Interactive comment on “Open check dams and large wood: head losses and release conditions” by Guillaume Piton et al.

Guillaume Piton et al.

Received and published: 27 July 2020

Fig. 1. Figure 1: Froude number with and without LW for each dam type

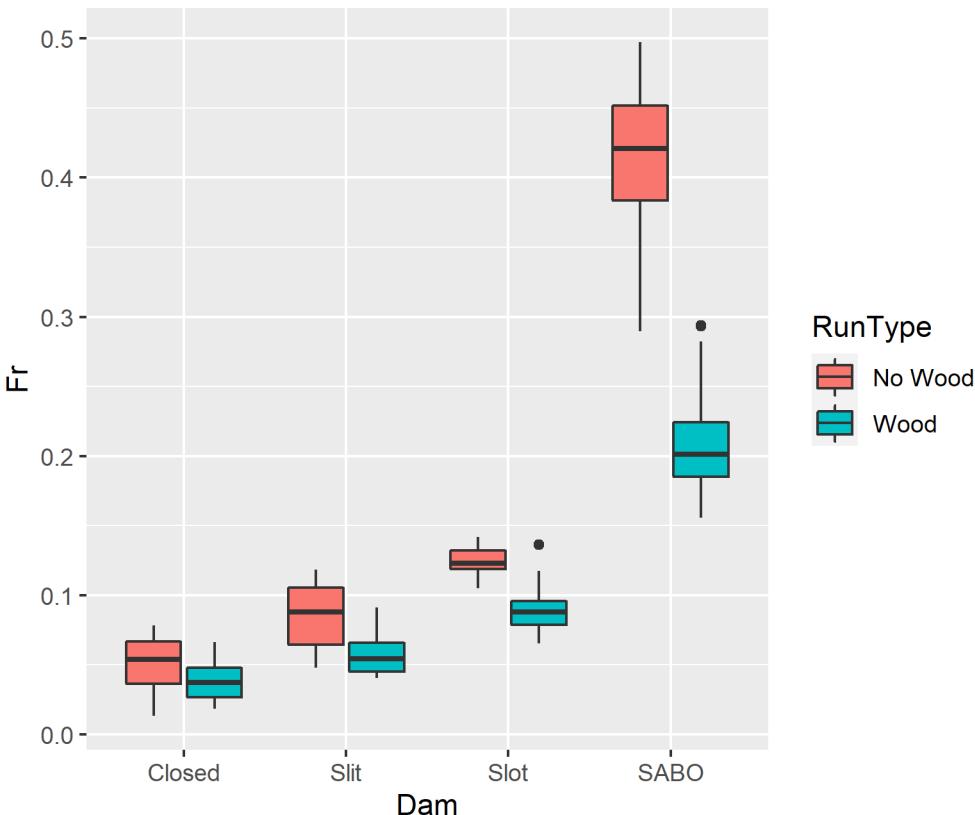
Reviewer Comment: 24. L98: The authors state a range of flow Froude number F between 0.01 and 0.3. F = 0.01 this is very small; is this a common value at check dams - in particular when the authors stated in L80 that the flow Froude number is expected to be larger at check-dams compared to reservoir dams. Please discuss.

Froude number with LW varies between 0.01 and 0.3. It was specifically low for the closed dam, which is quite similar to a dam reservoir structure. The bigger the opening, the higher the Froude number as shown in Figure 1.

We know from other experiments with the same flume setting that the Froude number without structure would be close from 0.7 but the presence of open check dams tend to create a significant backwater and decrease of the Froude Number directly upstream.

In the revised version of the paper, the following mention will be added in the Material and methods section: “The mean value \pm standard deviation of the Froude number was 0.04 ± 0.01 , 0.06 ± 0.02 , 0.1 ± 0.02 and 0.24 ± 0.08 for the closed, slit, slot and Sabo dam, respectively (see section 3.2 for dams’ features).”
